List of Recommended Alternative Products for the LND Series

LND Series will be discontinued at March 31, 2014. LND2 Series is recommended as replacement.

Mar. 2013

Diagrams Discontinued Products: LND Series

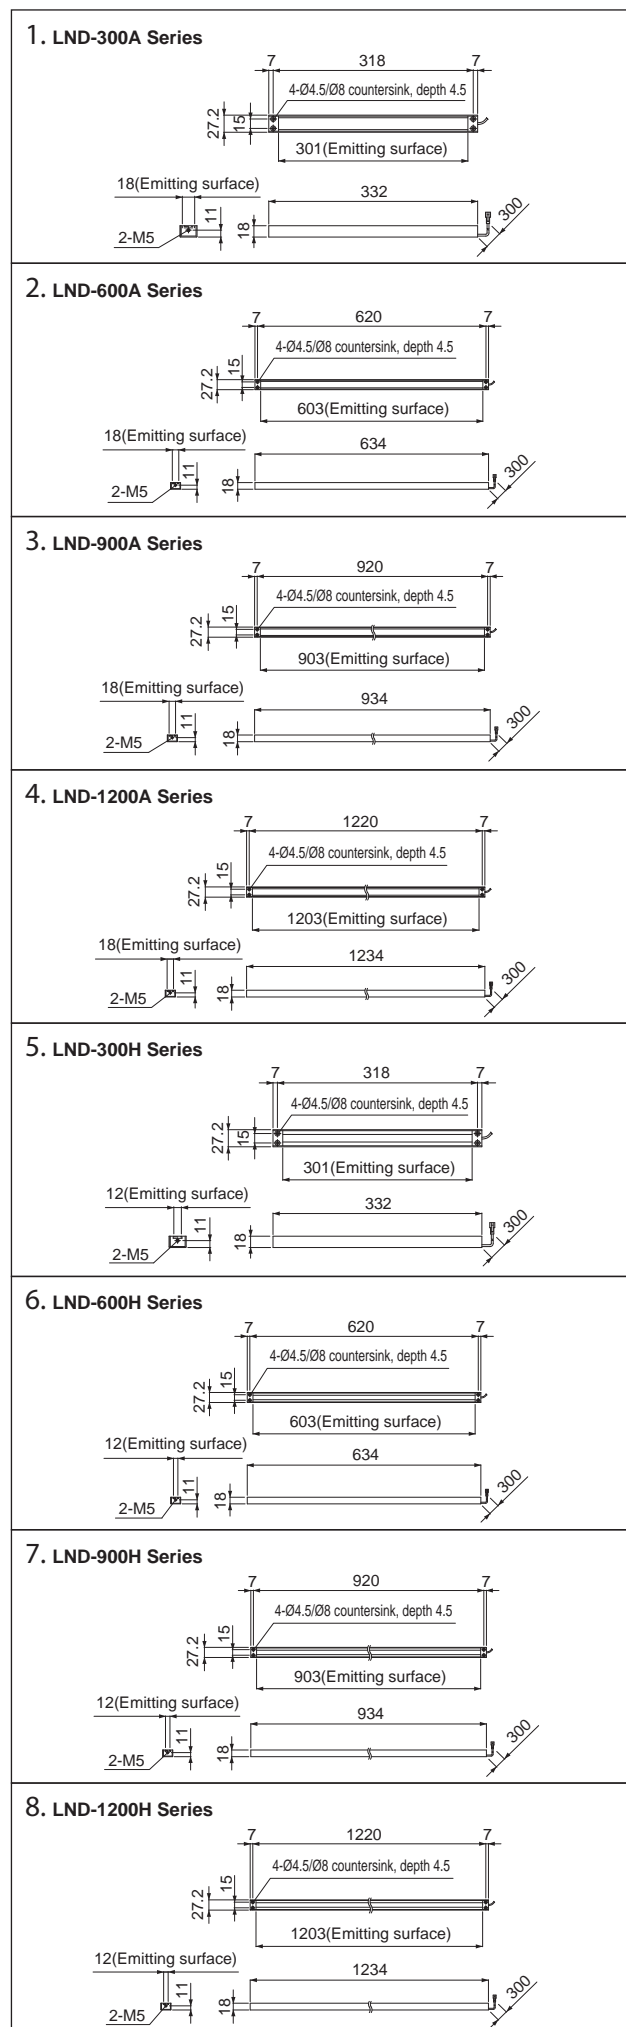
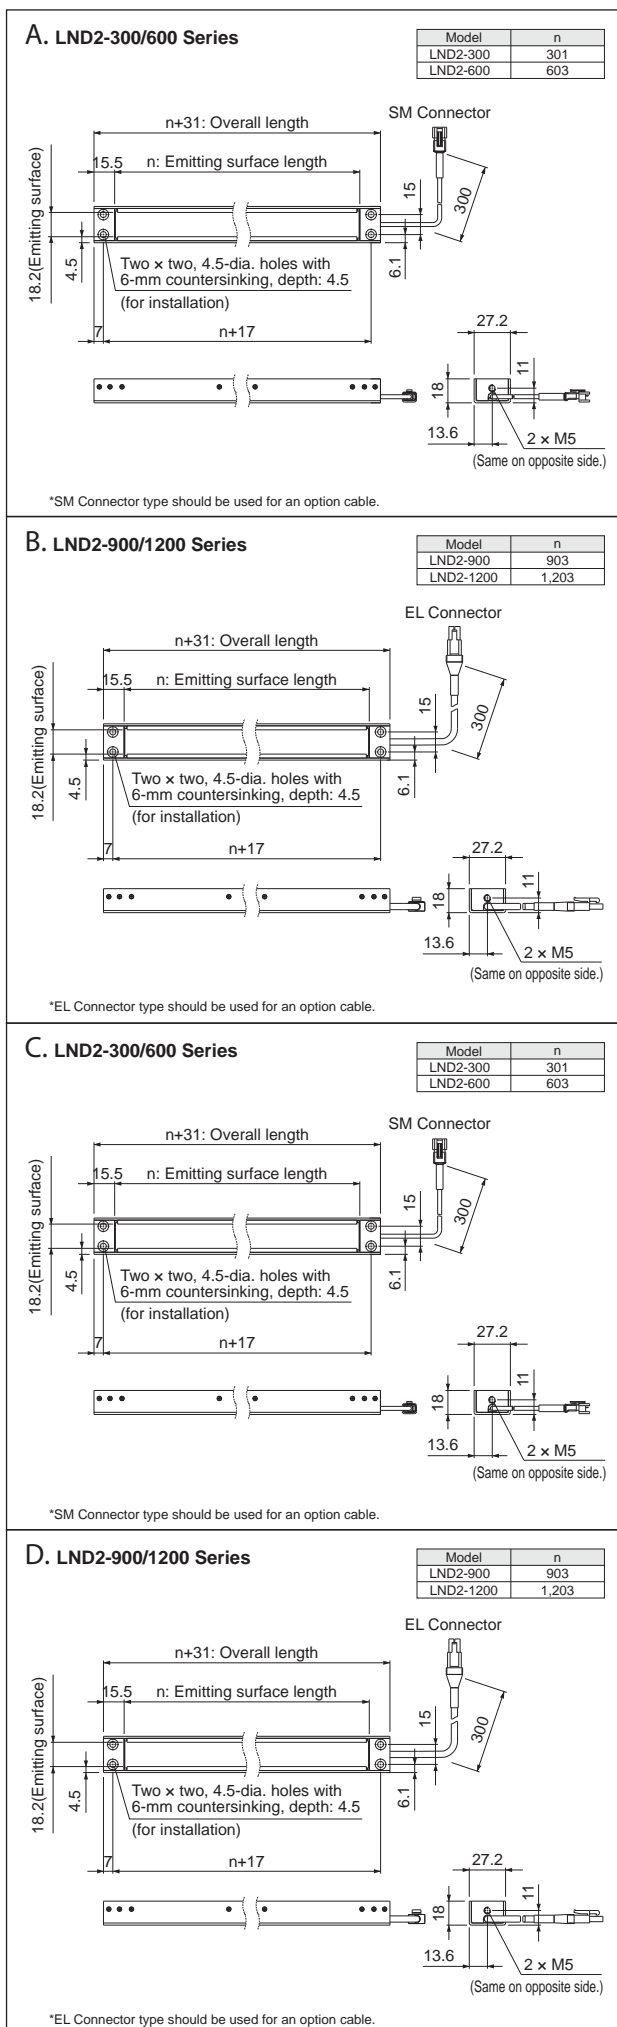
* Lineup includes LED Colors of Red and White. Blue/Green can be provided as a custom product.				
						* Length of the emitting surface has been unified to 18.2mm, while that of the previous models were 12/18mm.

* Power consumptions have been changed.				
						* Peak wavelength of the Red light has been changed to 635nm, while that of the previous model was 660nm.

* Dimensions of the products / size of the emitting surface have been changed. Please turn over for details.									
	* SM connector is used for the Light Unit whose emitting-surface length is equal to or less than 603mm. EL connector is used for the Light Unit whose emitting-surface length is equal to or more than 903mm. Please note that the applicable Control Units and the extension cables are depend on the type of the connecor.

Diagrams of Recommended Alternative Products: LND2 Series
